RE: Deficiency Letter for Letter of Interpretation - Line Verification  
**File No.: 1427-06-0005.1 (FWW 090001)**  
Applicant: David Norrie, Esq.  
Block: 1201; Lot: 7  
Mount Olive Township, Morris County

I am writing with regard to the above referenced application for a Letter of Interpretation (LOI) – Line Verification. As observed on my site inspection of March 25, 2010, additional wetlands are present on the subject property besides those depicted on the submitted plan prepared by Hallard & Associates, dated June 23, 2005, unrevised. The mapping is deficient with regard to the points noted below.

Attachment (mapping portion)

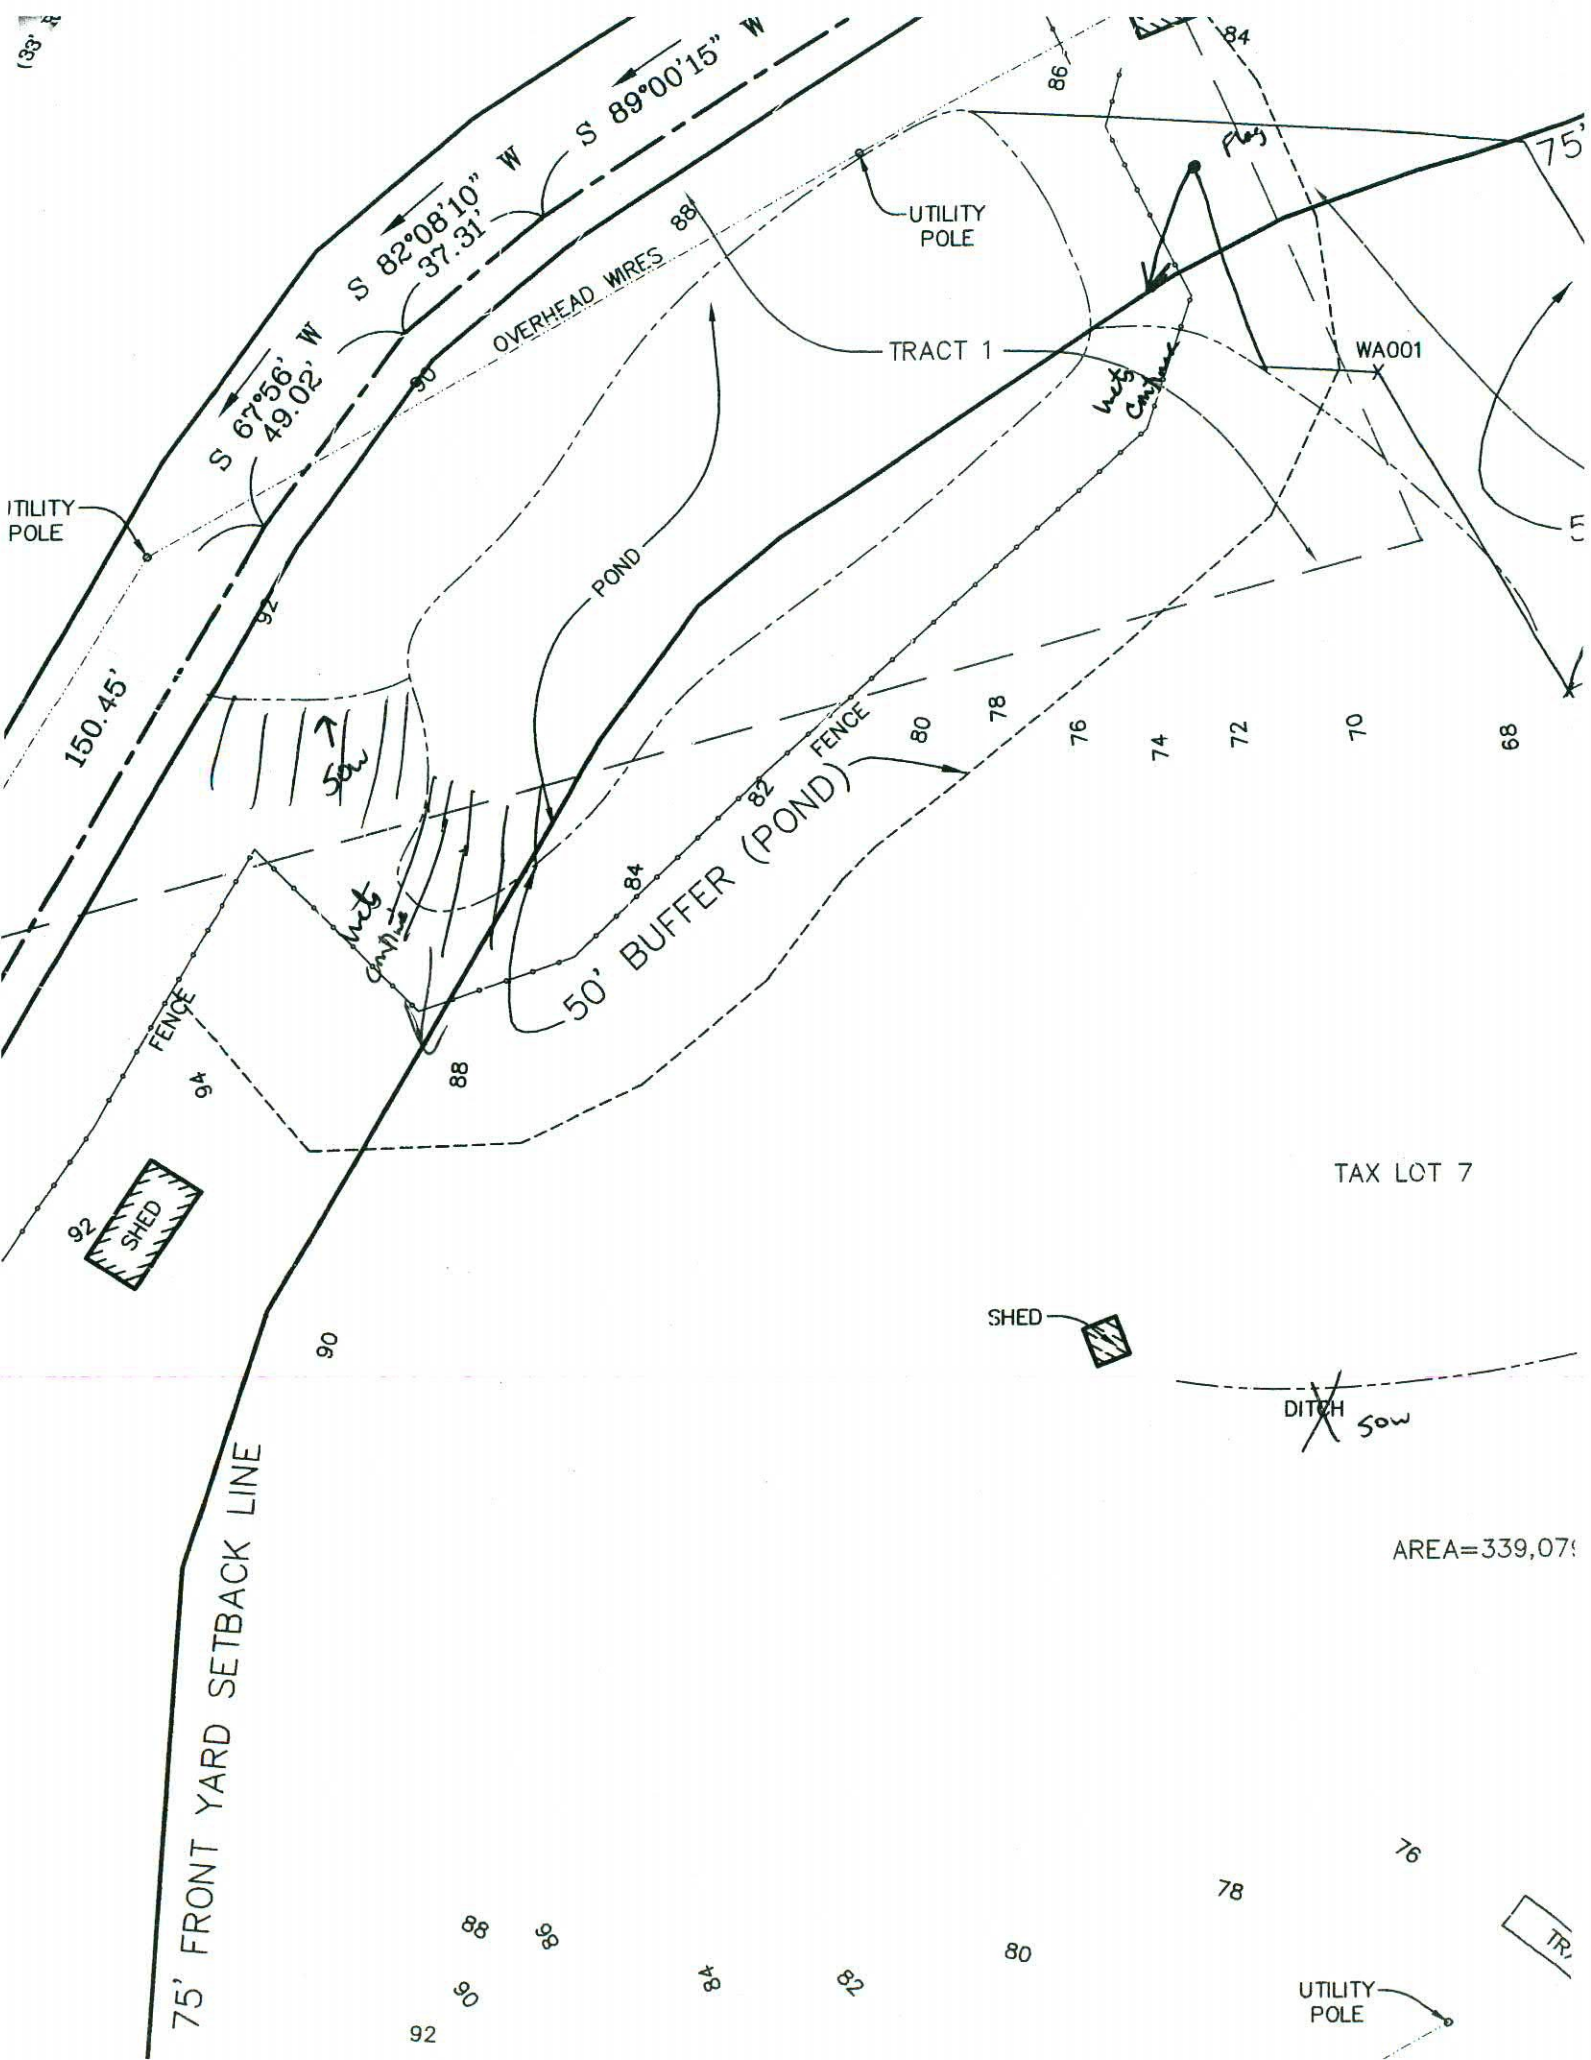
1. Additional wetlands are present within the field area, north and east of flagged points WA002 through WA008. The area contains hydric soil colors with redoximorphic features and saturated soils. I hung seven orange flags to delineate the extent of this area (numbered DEP 1 – 7, for connection to WA010 and WA002). A sketch of this area is attached for general information. These additional points will need to be surveyed for inclusion on a revised plan.

2. The revised plan needs to specify on which side of the boundary the wetlands are located, for example, with labels for wetlands and uplands, or with graphics.

3. The submitted plan does not accurately depict the State open water feature which extends from a pipe located east of the on-site pond. I hung one orange flag at the head of this feature. This feature needs to be depicted on the revised plan. In addition, while wetlands do not appear to be located within the grassed area between the roadway and pond, wetlands are present on the western side of this additional State open water feature, along the rear embankment of the pond, and within the western portion of the pond.

4. The wetland delineation needs to be updated so that the boundary ends at the property boundary (do not leave hanging wetland lines).

5. Delete the depiction of a stream located on the pond's eastern embankment as this feature does not exist. As noted above, depict the State open water feature as it exists in the field.
6. Delete the 50' wetland buffer as this is not applicable.
7. Label and include in the revised delineation the State open water feature which enters the pond from the pipe under Crease Road.
8. Delete the term "ditch" for the features extending from the pond and running through the center of the site. Label these as State open waters instead.
